**CITY OF DELAWARE
PLANNING COMMISSION
AGENDA**

JANUARY 20, 2016

PLANNING COMMISSION / STAFF REPORT

CITY OF DELAWARE, DELAWARE COUNTY, OHIO
 REAL DEVELOPMENT PLAN
SECTION I
 GLENGROSS NORTH
 ILLUSTRATIVE SITE PLAN

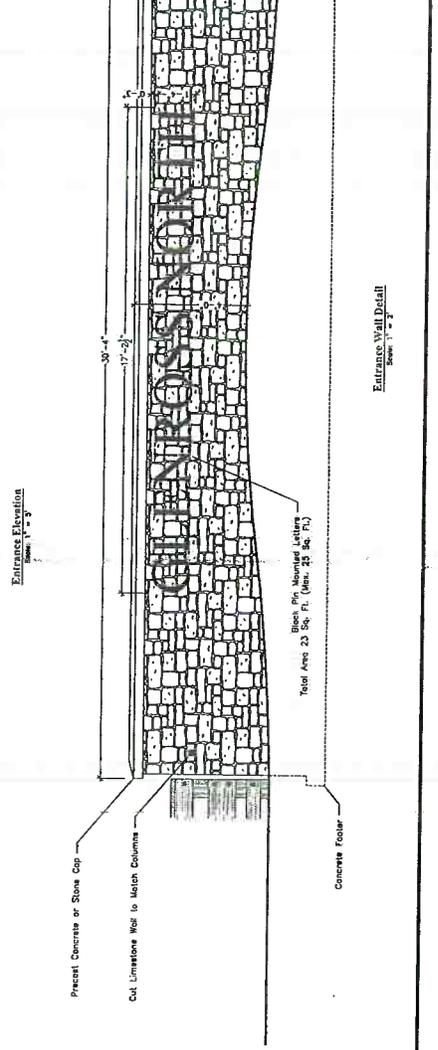
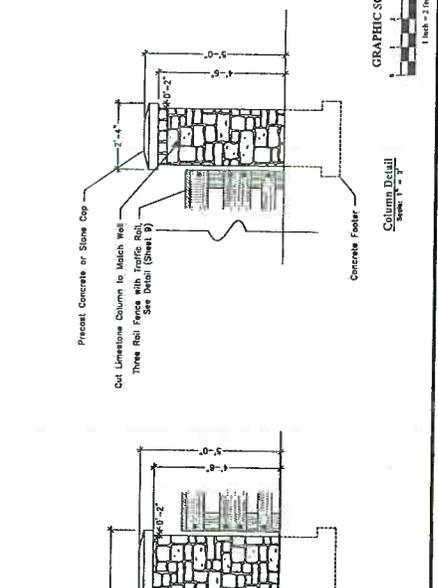
2. All retention ponds shall be setback a minimum of 80 feet from the edge of pavement for roads of 35 mph or higher or per the City Engineer.
3. The lots and houses shall comply with the minimum bulk and setback requirements in the approved development text.

5. A minimum 3 foot high mound with landscaping shall be located along Glenn Parkway between the house lots and the retentions pond. In addition, a three rail wood fence stained white shall be installed adjacent to the retention pond along Glenn Parkway and the main entrance road (Sycamore Lane). The maintenance of the mound and associated landscaping shall be the responsibility of the Homeowner's Association. The subject plan shall be reviewed and approved by the Shade Tree Commission.

6. A street tree plan shall be submitted and approved by the Shade Tree Commission.
7. A tree preservation area shall be established along the east and south single family lot lines of Section 1.

STREET, STORM, WATER AND LIGHTING PLAN
SECTION 6
THE COMMUNITIES AT GLENROSS
FOR
CITY OF DELAWARE, OHIO
STREET TREE PLAN

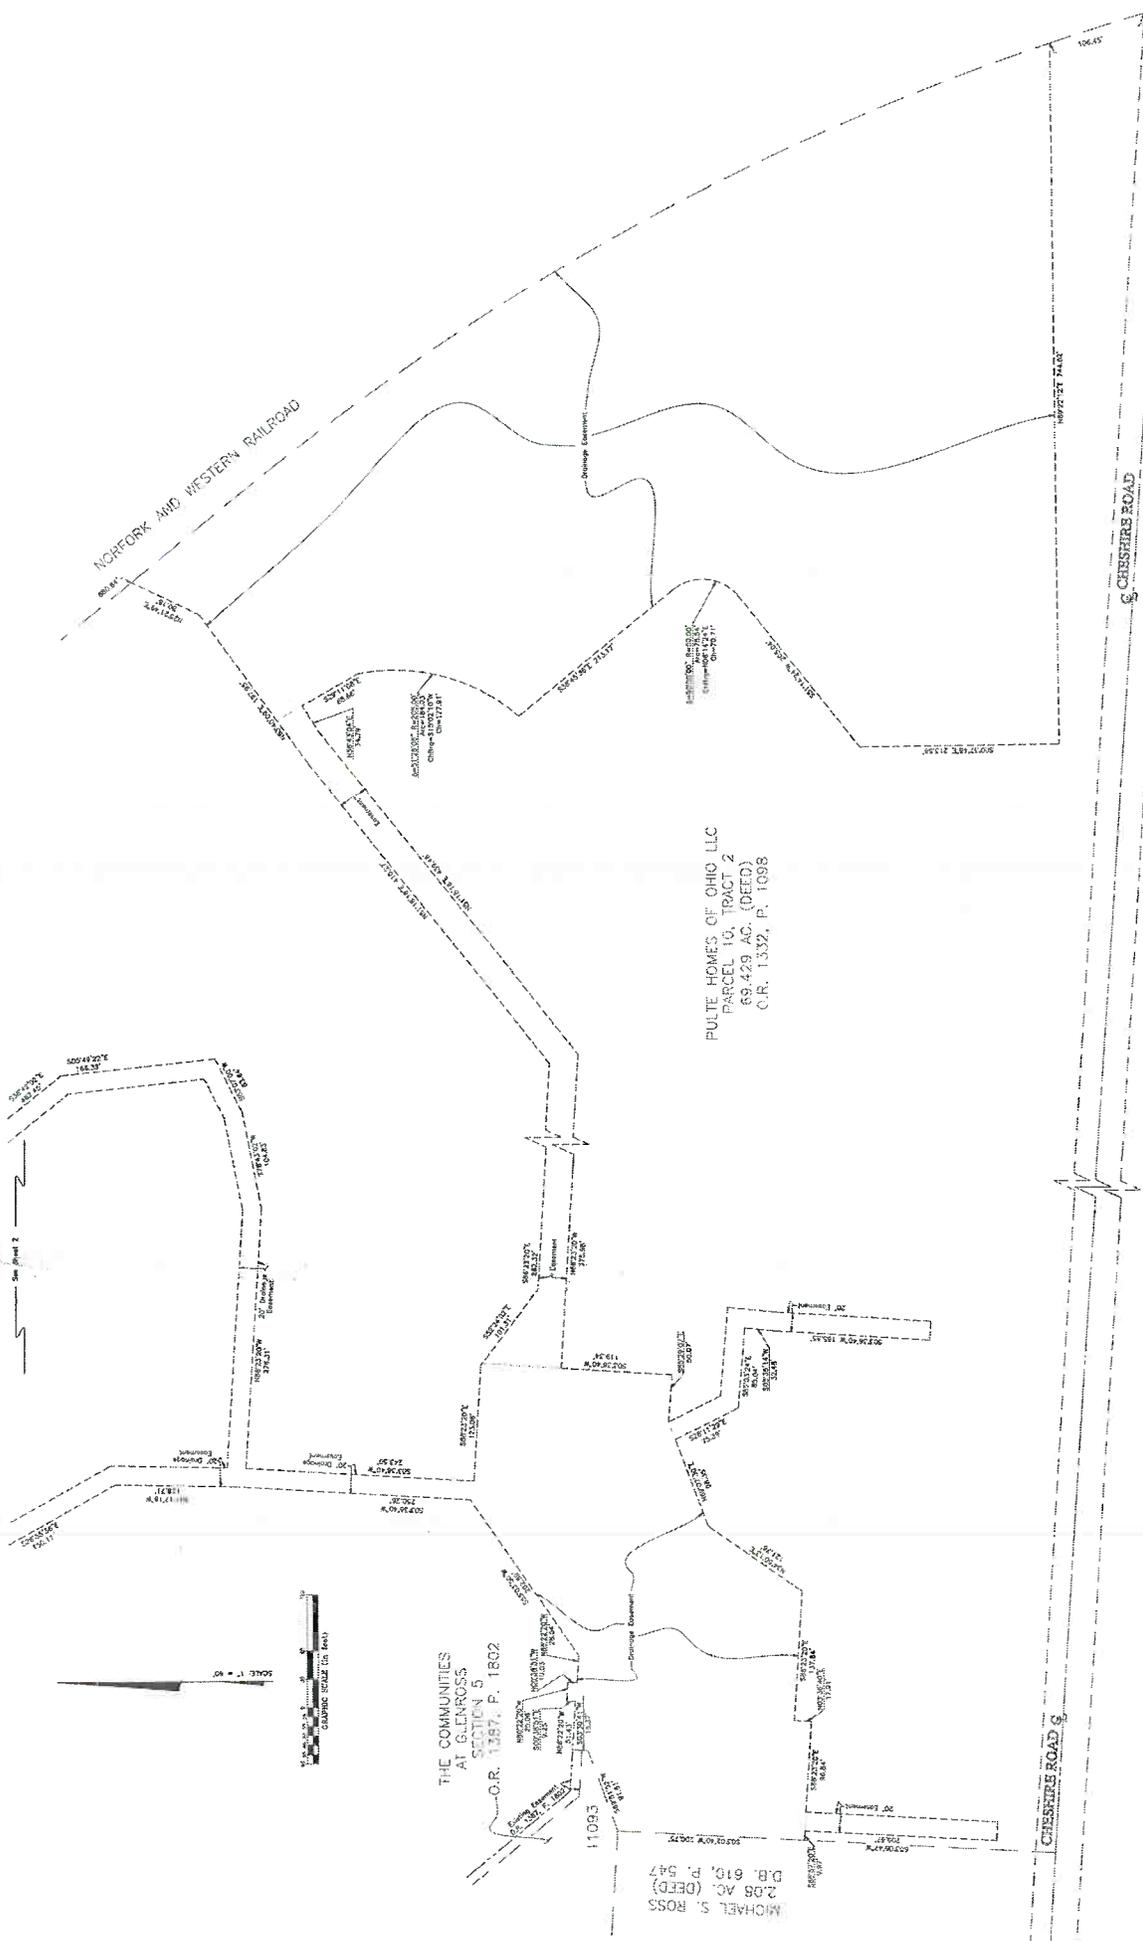
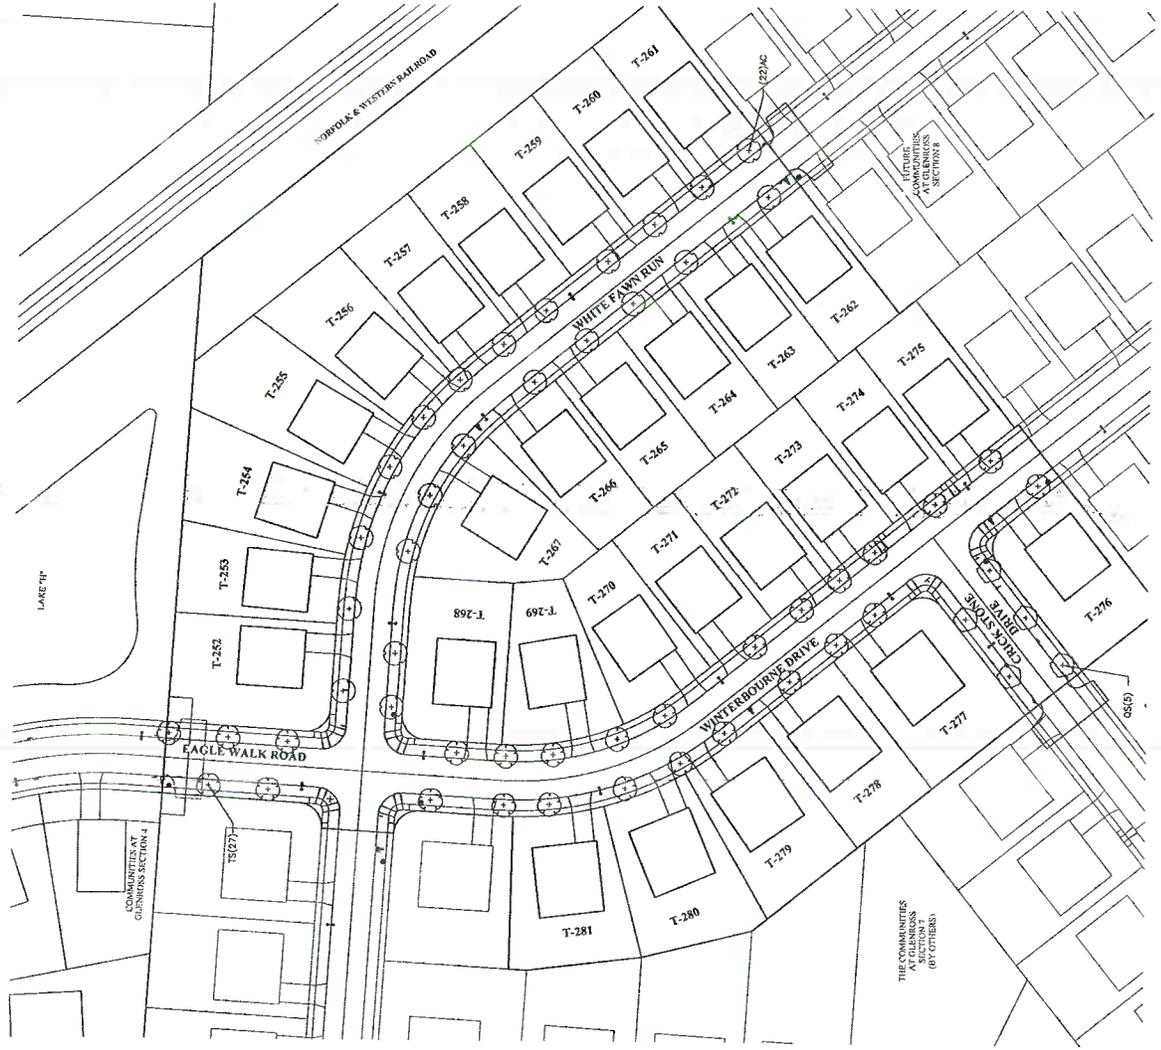
4. The street tree plan shall be reviewed and approved by the Shade Tree Commission.
5. A 10-12 foot high mound with landscaping shall be installed adjacent to the railroad tracks to be consistent with mounding in Section 4 of the Communities at Glenross just north of the subject section. The mounding and landscaping shall be the maintenance responsibility of the Home Owners Association (HOA) in perpetuity. No changes to the mounding or landscaping shall be allowed without the approval of the City of Delaware. The applicant may make allowances for individual homeowners to mow and otherwise maintain this area so long as no improvements are altered, but the final maintenance responsibility shall rest with the HOA. The subject plan shall be reviewed and approved by the Shade Tree Commission.
